JONES & BEACH ENGINEERS INC.

October 22, 2024

RE: Response Letter 3
635 Sagamore Ave, Portsmouth, NH
Tax Map 222, Lot 19
JBE Project No. 18134.1

We are in receipt of comments from Eric Weinrieb, P.E., Altus Engineering dated October 7, 2024 and Stefanie Casella, Portsmouth Planning Department, dated September 30, 2024. Review comments are listed below with our responses in bold. In addition to the comments listed below, we have also added a proposed radar speed sign near the intersection of Sagamore Avenue and Cliff Road as requested by Eric Eby. This sign is shown on Sheet H1 of the plan set and standard specifications for the sign have been added to Sheet D6.

FRONT ELEVATION
1/4" = 1'-0"

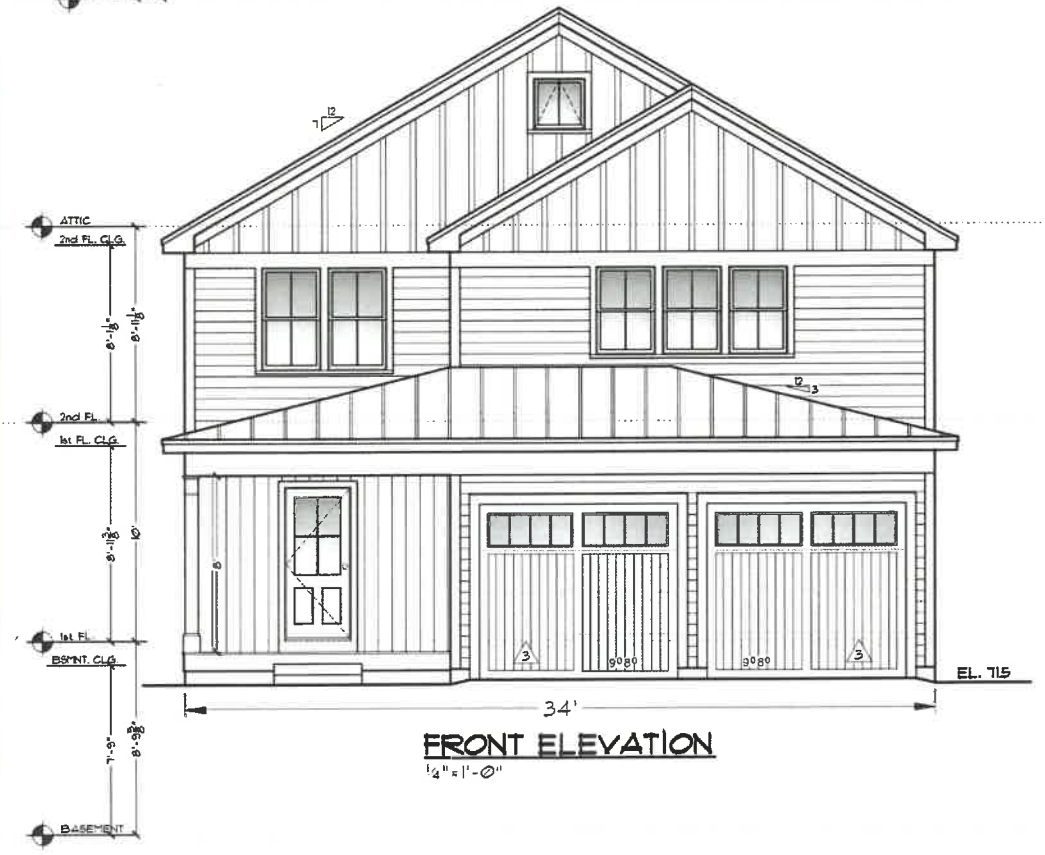
2. Please provide the height of all structures based on the definition found in the Zoning Ordinance.

RESPONSE: Building heights have been added to the architectural plans.

DRAWING No.
C3
 SHEET 6 OF 21
 JBE PROJECT NO. 18134.1

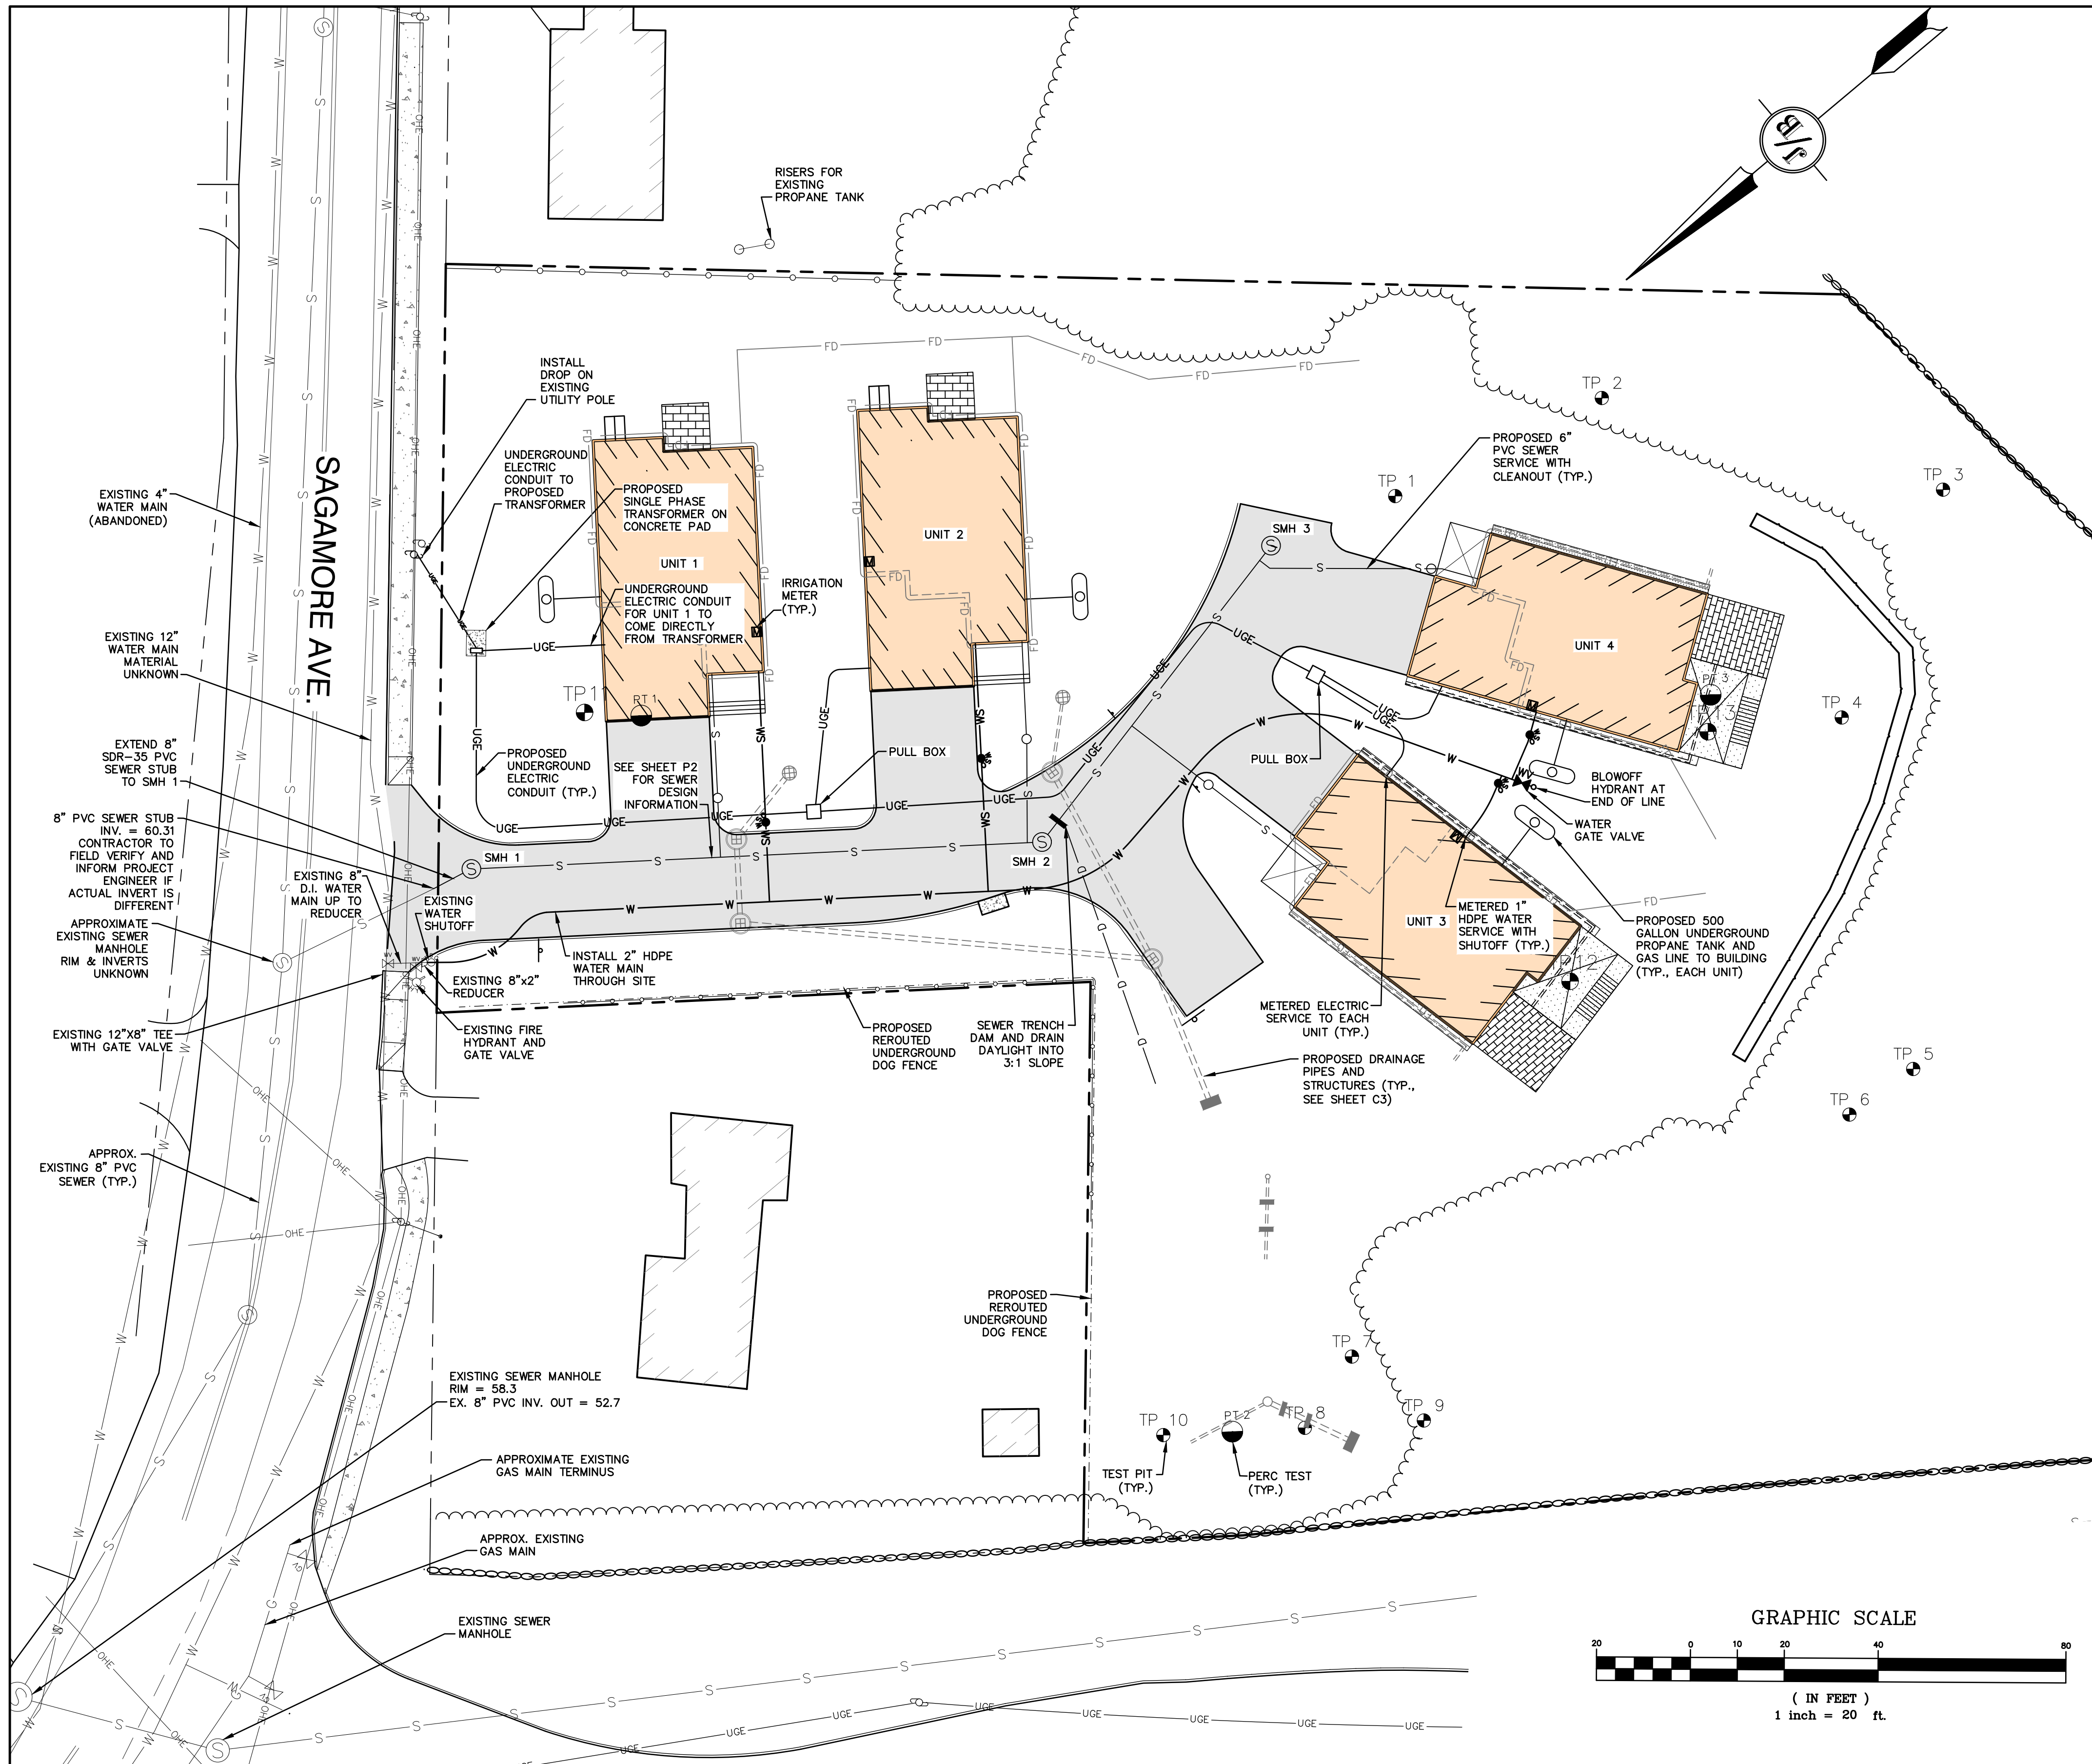
1. Based on the discussion at the October 1st TAC meeting, it is understood the Designer was going to expand the retaining wall and move it closer to buildings 3 and 4, making the wall higher, while preserving more of the natural vegetation. This will also provide more fill material for the absorption of the roof and perimeter drain runoff and additional soil for the proposed landscaping. In general, Altus supports this approach and will provide comment on the design when the revised plans and documents are submitted.

5.Behind units 3 & 4, it seems like if the proposed boulder retaining wall was extended along the path of the proposed 60 contour, a number of existing trees could be saved and the additional plantings that are proposed could then be planted uphill of the wall. This would provide a sufficiently sloped and adequate 'back yard' and the fill soil for the wall would provide enough soil for the new shrubs and plantings to grow into a nice screen placed between the 64 and 60 contour.

RESPONSE: We have extended the proposed retaining wall and moved the proposed plantings to the high side of it in order to preserve existing vegetation, provide more of a visual buffer, and provide additional soil beneath the proposed landscaping.

RESPONSE: We have extended the proposed boulder retaining wall as shown in Sheet C3. Plantings have been moved to the uphill side of the retaining wall as shown on Sheet L2 and we are now maintaining more of a natural vegetated buffer.

SAND ABSORPTION AREA

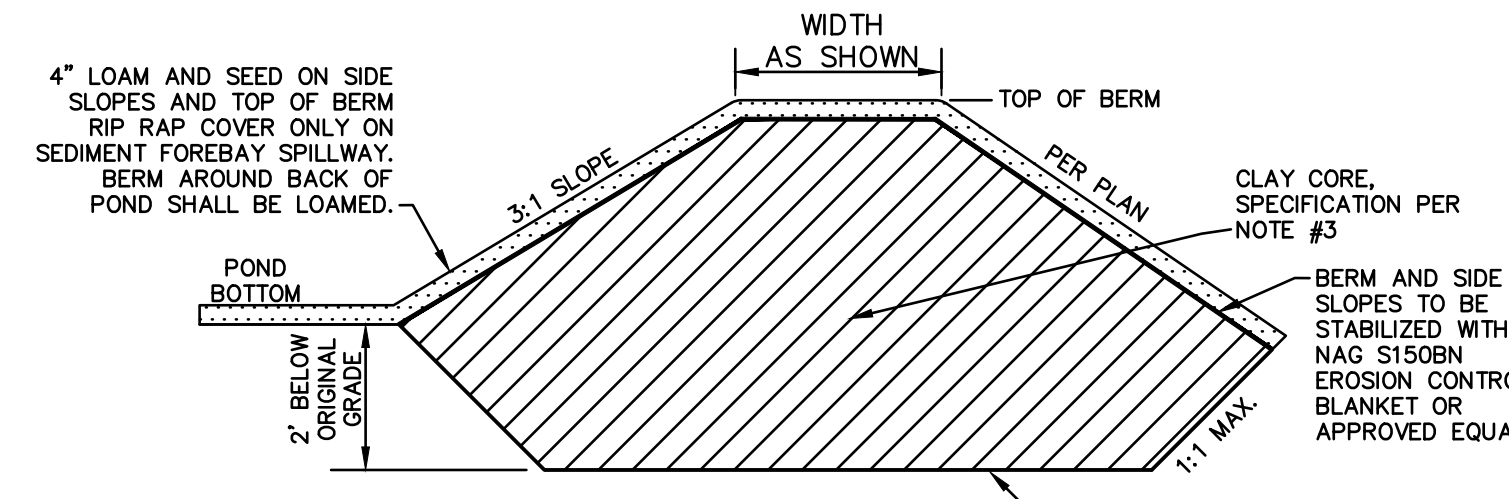
3. The Designer is now specifying a “sand absorption area” for the perimeter drain collection/infiltration system. The Designer needs to provide details for this treatment device including bedding material, bedding preparation, inverts, surface treatment, maintenance requirements, soil absorption capacity, and down gradient material requirements. As drawn, it appears that the discharge pipes will be on the ground surface without adequate cover. The design should provide material specifications for the downgradient fill material and how the materials will interface.

RESPONSE: A detail for the sand absorption area has been added to Sheet D4. This detail specifies the depth of sand, a sieve specification for the sand material, and the specification for the berm, subgrade, and downgradient material. Additionally, we have noted on Sheet C3 that a 3’ wide overflow spillway shall be added 3” above the top of sand, and that the foundation drain shall outlet at or above the spillway elevation so that water does not back up into the unit basements.
